ADDENDUM NO. 2

Ithaca Fire Station
Wendel Project No. 618601

Project Ithaca Fire Station Addendum No. 02
Contract _____
Wendel Project No. 618601 Date 9/13/2023

SECOND FLOOR PLAN -
LIGHTING

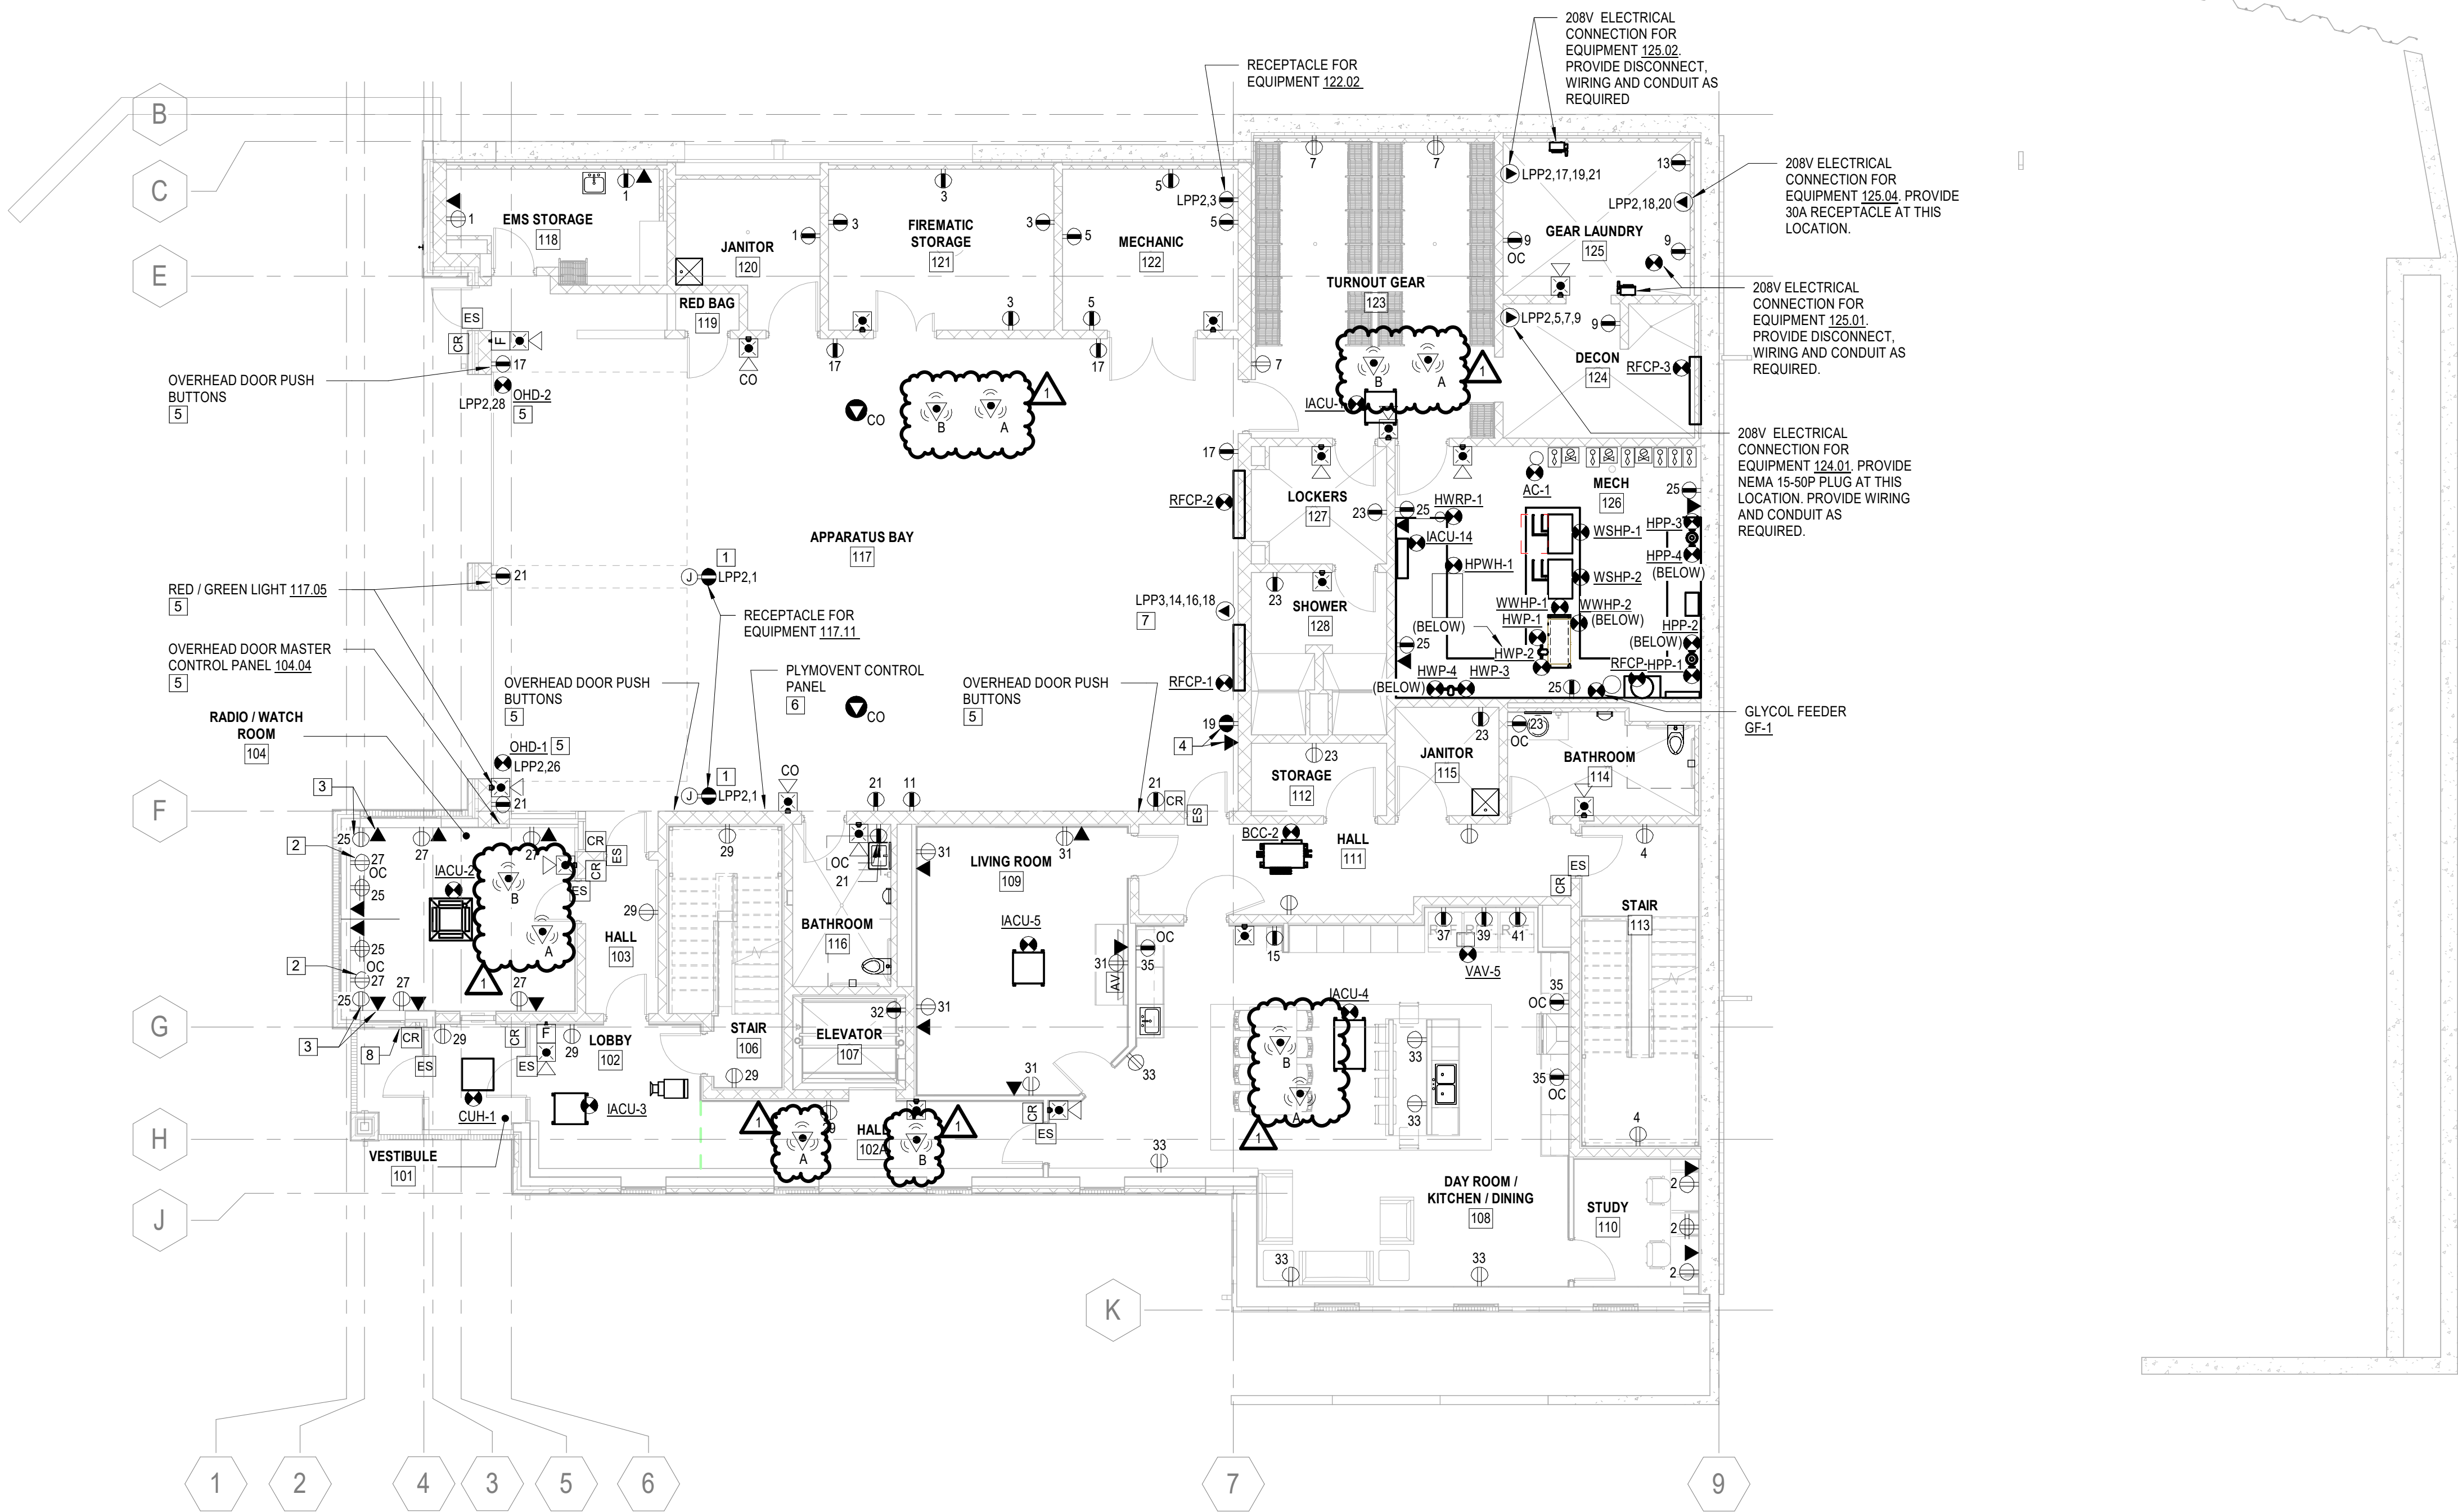
2. On the second floor lighting plan, there are symbols that appear to exit signs but they are obscured by a question mark (?) Are these symbols exit signs? Also, the exit signs do not appear on the Light Fixture Schedule.

The light fixture questions will be clarified in Addendum No.2
